Access Compliance Report

Public Rights-of-Way

Intersection ID: 44063	Main Street: SEDGEMOOR_LN	Cross Street: GRAYWELL_LN	Location: W
ADA ID: D92F26B68048	Ramp Type: PerpDiag	Initial Pass/Fail: Fail	Overall Compliance: No
		Severity Score: 22.5

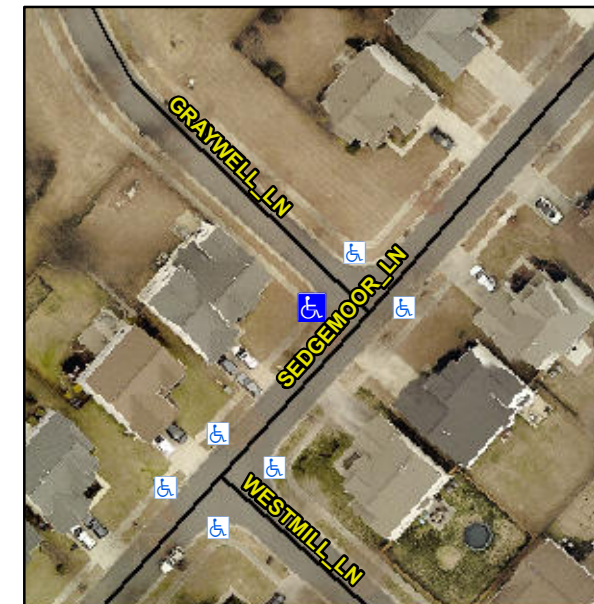
R304.5.1, R304.2.2, R304.5.3

Compliance	Description	Data	Compliance	Description	Data
N/A	Ramp Length (in)	53.0	No	Ramp Slope (%)	8.5
No	Ramp Width (in)	36.0	No	Ramp XSlope (%)	2.8
N/A	Flare Type LT	N/A	N/A	Flare Type RT	N/A
N/A	Flare Slope LT (%)	N/A	N/A	Flare Slope RT (%)	N/A
N/A	Flare Traversable LT?	N/A	N/A	Flare Traversable RT?	N/A
N/A	Landing Length (in)	N/A	N/A	DWS Provided?	N/A
N/A	Landing Width (in)	N/A	N/A	DWS Contrast?	N/A
N/A	Landing Slope (%)	N/A	N/A	DWS Length (in)	N/A
N/A	Landing X Slope (%)	N/A	N/A	DWS Full Width?	N/A
N/A	Landing Curb? (Y/N)	N/A	N/A	DWS Offset (in)	N/A
N/A	Shared Landing?	N/A			
N/A	Gutter Ponding?	N/A	N/A	Gutter Slope (%)	N/A
N/A	Gutter Lip Ht (in)	N/A	N/A	Gutter X Slope (%)	N/A
N/A	Painted X Walk1?	No	N/A	Painted X Walk2?	No
	X Walk 1 Direction	To NE		X Walk 2 Direction	To SE
N/A	X Walk 1 Width (in)	N/A	N/A	X Walk 2 Width (in)	N/A
	X Walk 1 Slope (%)	4.8		X Walk 2 Slope (%)	2.2
	X Walk 1 X Slope (%)	1.4		X Walk 2 X Slope (%)	3.3

Remove & Replace Curb Ramp With Two New Directional Ramps or Equivalent.
